FIELD OBSERVATION – SECOND FLOOR CEILING REPORT 06-15-2016

Report Date: 07/11/2016

AEI Project Number and Name: 14018 – The Park Danforth

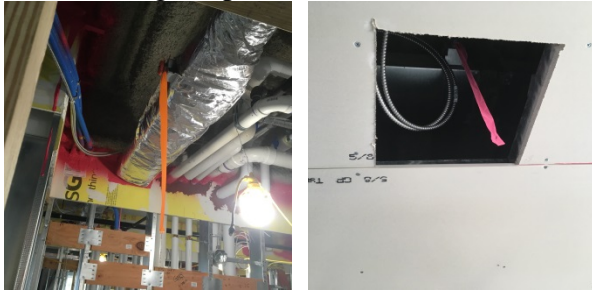
1. Adjust saddles to be centered below clevis hanger.

2. Adjust hangers so that piping is supported, and does not have any peaks or valleys in horizontal span and runs straight in vertical positions.

3. Verify all VD's are in accessible locations, either above acoustical tiled ceilings or have access panels coordinated with architect. Provide identification to locate each VD on ceiling according to spec section 230553.

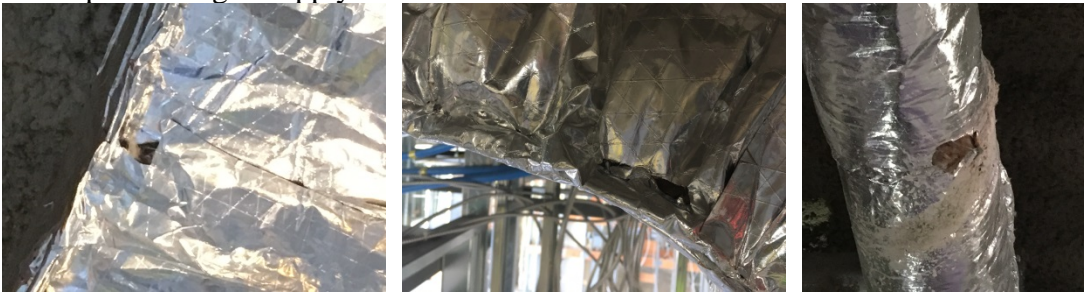
4. Repair damaged supply duct insulation.

5. Complete exhaust duct installation.

6. Provide protection for showers during construction. Complete shower installation.

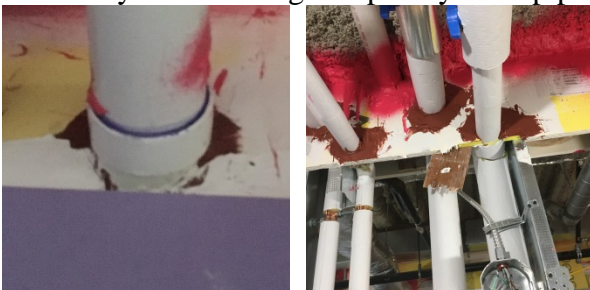
7. Seal holes in floor where not used for piping penetrations.

8. Seal supply duct insulation at fire rated wall.

9. Verify fire caulking completely seals pipe penetrations.

10. Cap unused vent tie in.

11. Complete toilet rough in from above, resolve conflict with exhaust duct.

12. Label piping throughout.
